Office Action Summary

09/925,724

HAUGHTON ET AL.

FIG. 1

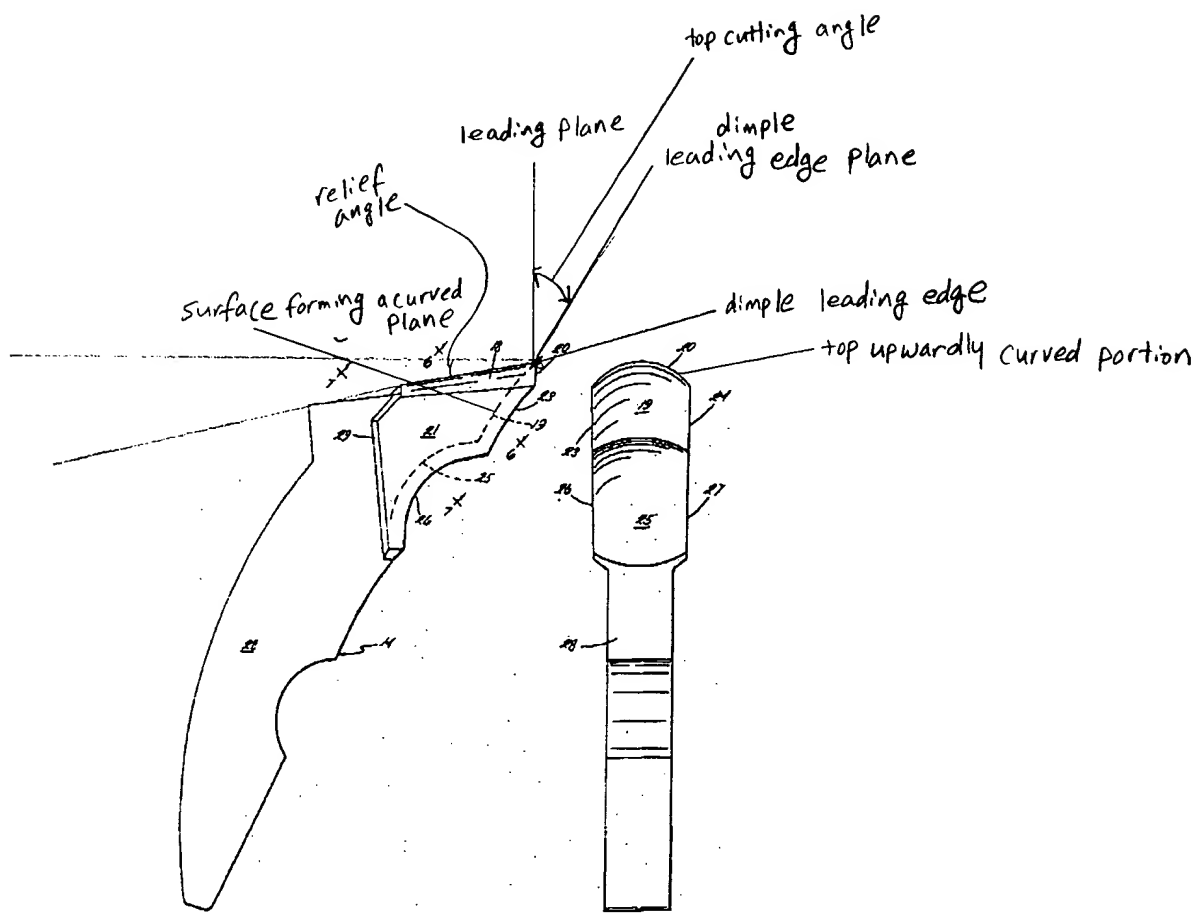
- a) a generally circular blade portion (col. 1, line 24);
- b) a plurality of spaced apart teeth having a leading plane and a dimple wherein the dimple having a dimple leading edge, a dimple leading edge plane, a top upwardly curved portion and a surface that is shaped inwardly from the top curved portion forming a curved plane and a top cutting angle wherein a positive rake defined by the top cutting angle formed by the dimple (see attached Figure A);
- c) a curved cutting edge (20).

Regarding claim 3, see Figure 1 wherein the leading plane is inclined forwardly. Regarding claims 4-5 and 10-11, see the attached Figure A wherein the positive rake is about 33 degrees. Regarding claims 6-7 and 12, see the attached Figure A wherein a relief angle is about 12 degrees. Regarding claims 8-9 and 13, a lateral clearance angle being between about 1.5 and about 5 degrees (col. 2, lines 69-70).

The examiner respectfully disagrees. As shown on the attached Figure A, the dimple in the Standal patent does show the dimple having a dimple leading edge, a dimple leading edge plane, a top upwardly curved portion, and a surface that is shaped inwardly from the top curved portion forming a curved plane. Furthermore, the attached Figure A also shows a positive rake provided by a top cutting angle of the dimple. As to the limitation the curved plane "having a radius curvature that decreases as the distance from the leading edge increases", see the rejections in paragraphs 2-5 above. As set forth above, the disclosure does not support such limitation and the examiner is unable to determine what structure is encompassed by that limitation.
